Re: Additional Information Department of the Army Application No. 2000-01534, New York State Department of Environmental Conservation No. 9-2934-00022/00230

**CWM Response to USACE August 26, 2013 Request for Additional Information**

**CWM RESPONSE TO REQUEST FOR ADDITIONAL  
INFORMATION  
JOINT APPLICATION FOR PERMIT  
FOR RESIDUALS MANAGEMENT UNIT NO. 2  
USACE REQUEST (dated August 26, 2013)**

## STOCKPILE LOCATIONS: EXISTING AND POTENTIAL

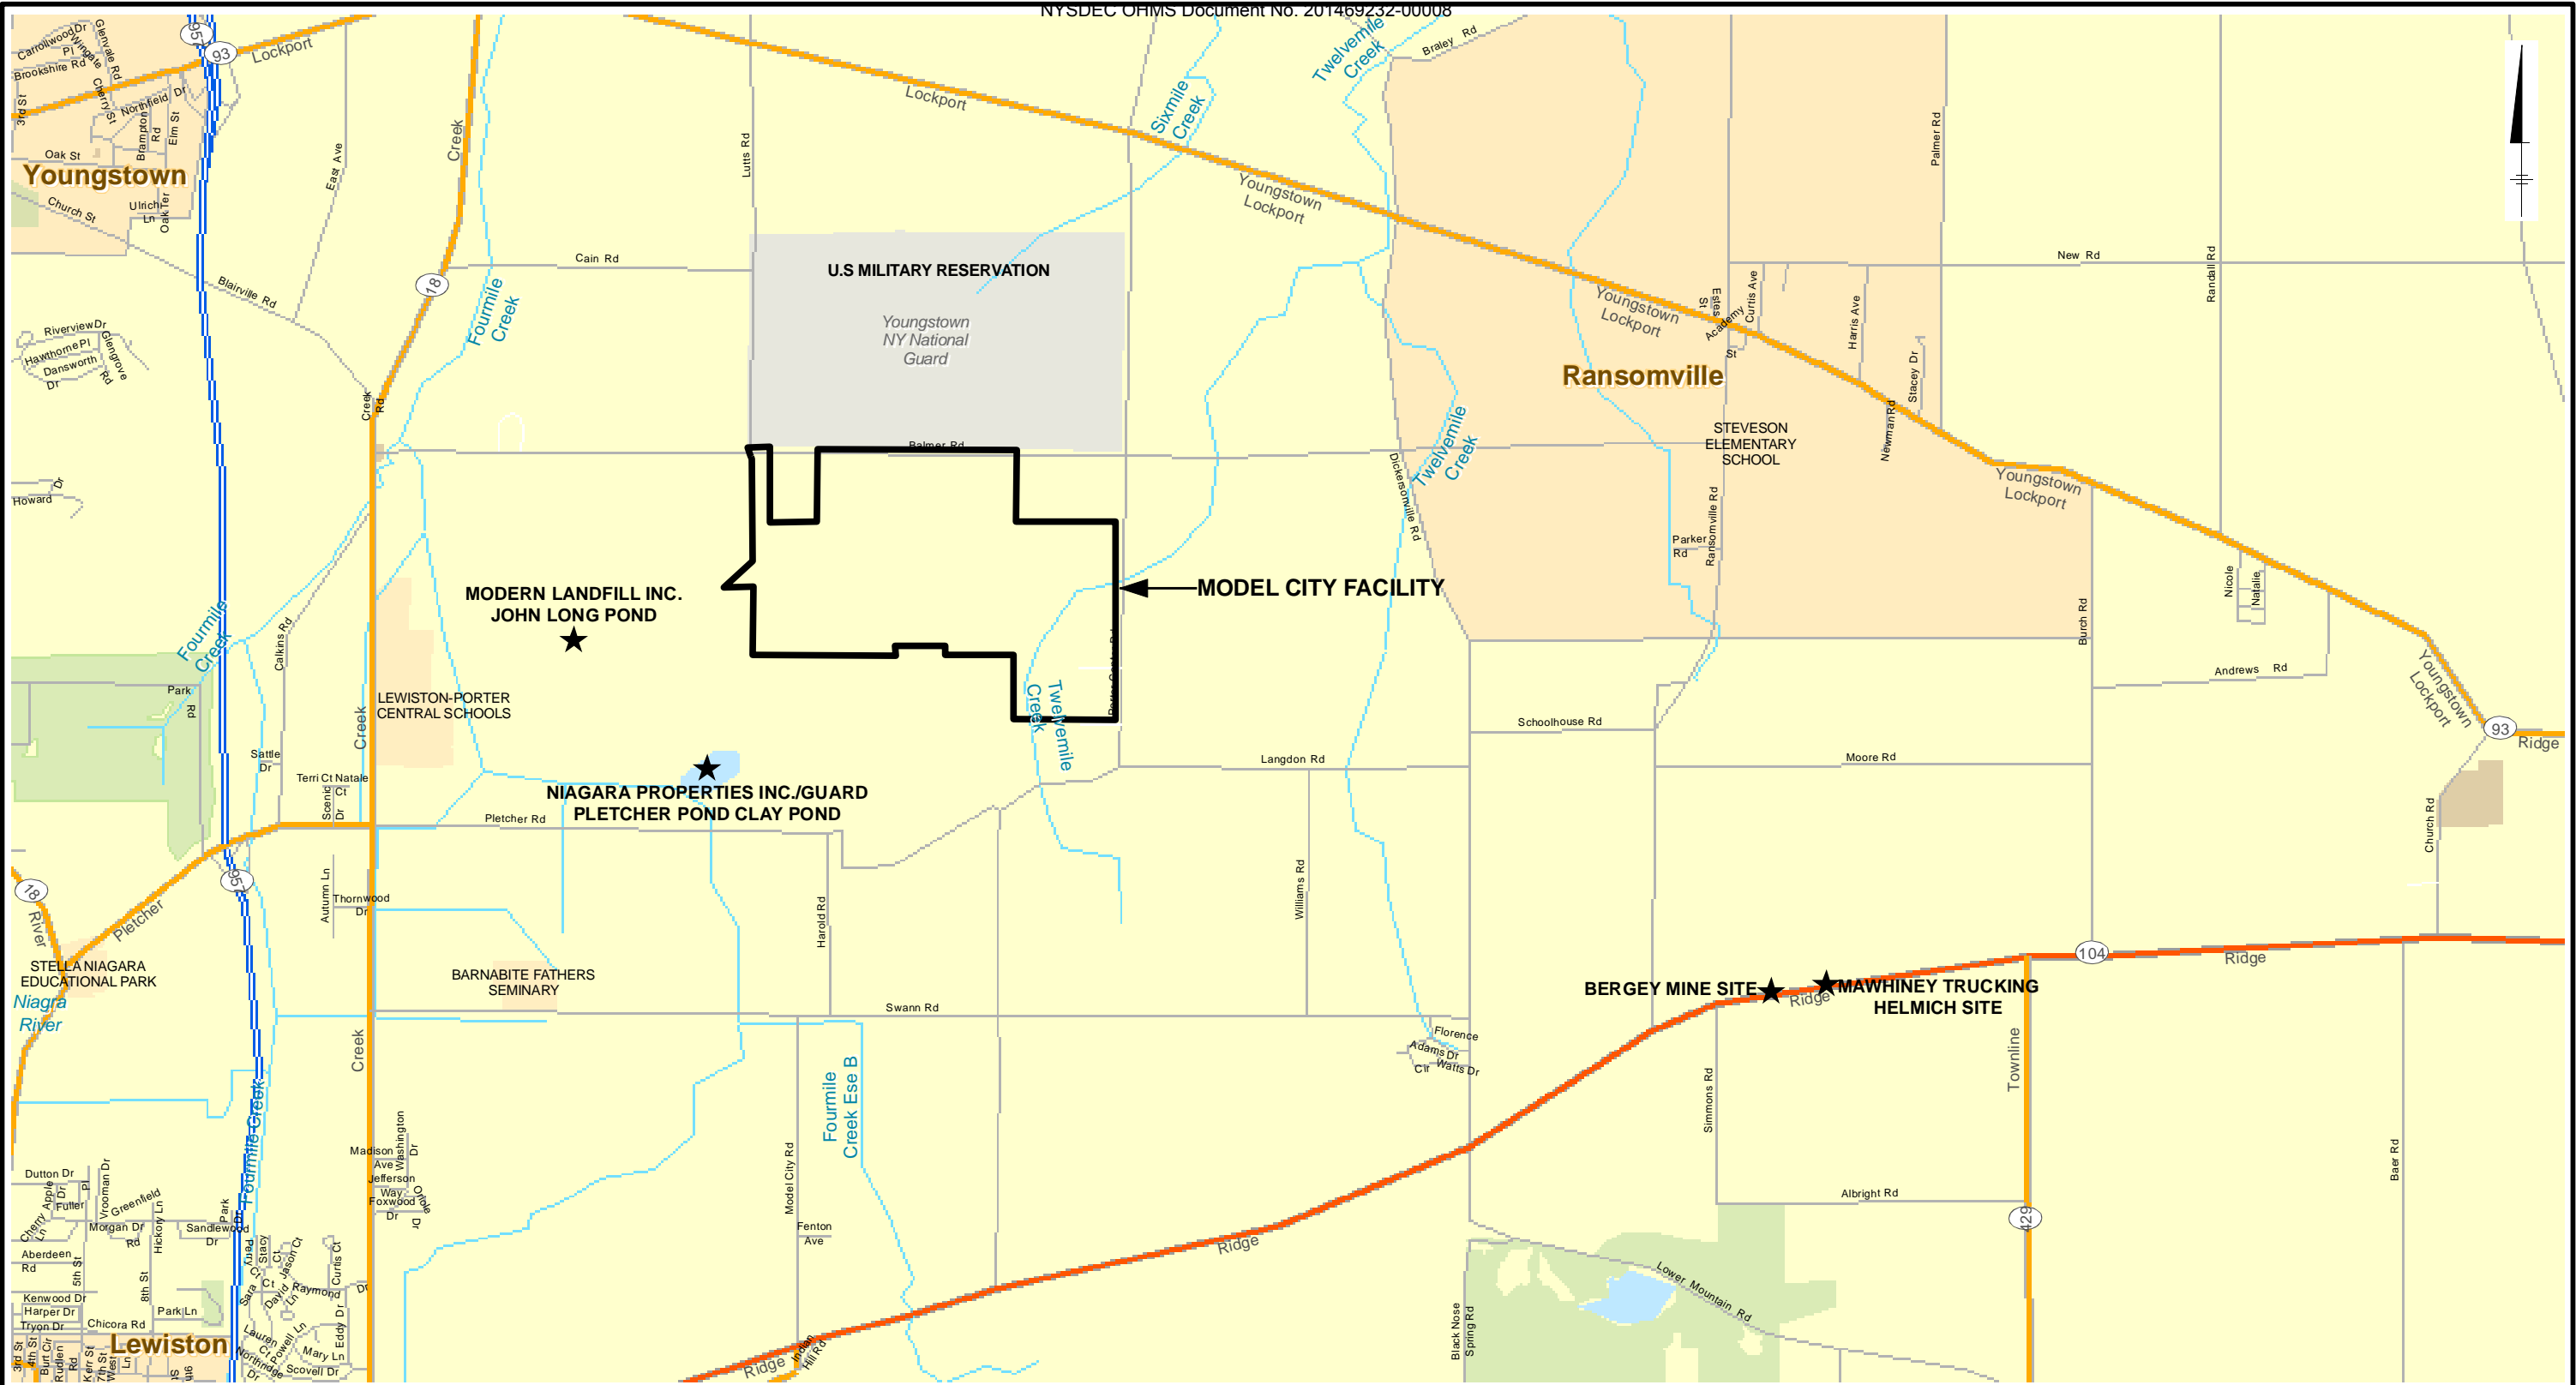
*Please identify the areas (if any) that will be used as soil borrow/stockpile areas.*

Appendix H of the Draft Environmental Impact Statement (DEIS) for the RMU-2 Project provides a soil management plan. Figure 1 from Appendix H of the DEIS is attached (Attachment 1) which shows current and potential soil stockpile locations that may be utilized during the development of RMU-2. A portion of the required soil materials for construction will be obtained from on-site excavation for RMU-2 and Fac Pond 5. Soils not available on site will be obtained from off-site sources on a contract basis. Section 2.6.6.5 and Appendix C of the DEIS provides details of potential off-site permitted borrow sources that may be utilized for the RMU-2 project. Also attached is a map showing the location of potential off-site soil borrow sources.

## RMU-2 SITE ALTERNATIVES

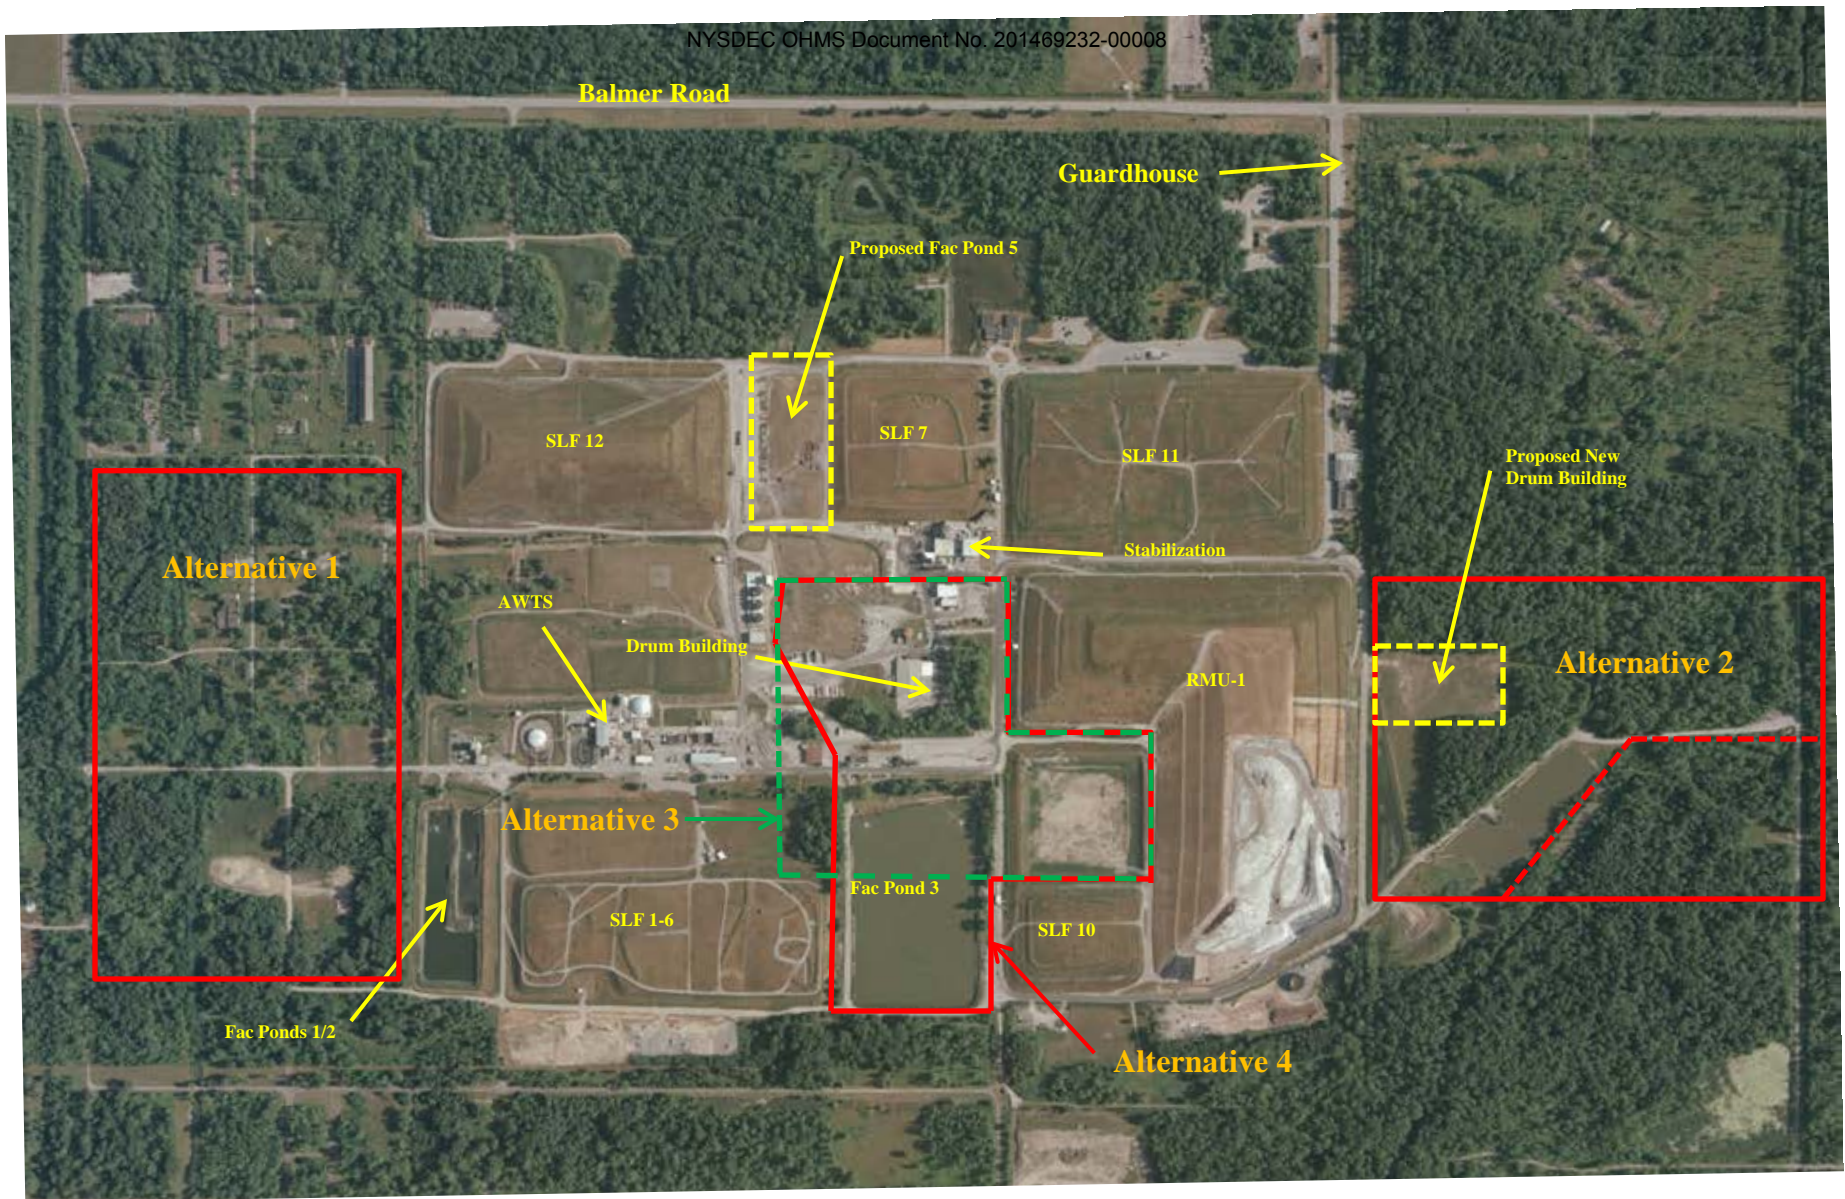
- A further analysis of alternatives to the work proposed. This information will aid us in determining whether or not the proposed work complies with the United States Protection Agency Guidelines at Title 40 of the Code of Federal Regulations Part 230.*
- Create a table that outlines the site life and wetland impact acreages for each of the CWM Facility alternatives and sub-alternatives, including the proposed RMU-2 footprint. Please include all associated impacts to Waters of the U.S. Finally, please include representative plans for each alternative with associated impacts.*

An analysis of alternatives is included in the Draft Environmental Impact Statement (DEIS) (Arcadis, 2013) for the RMU-2 Project with portions included in the Joint Application. Additional details of the analysis are included in Attachment 5. Attachment 5 includes a discussion of the various alternatives evaluated including a table which outlines the site life and impacted wetland acreages per alternative. Attachment 5 also includes figures showing the location of the onsite alternatives analyzed and associated wetlands in each area.
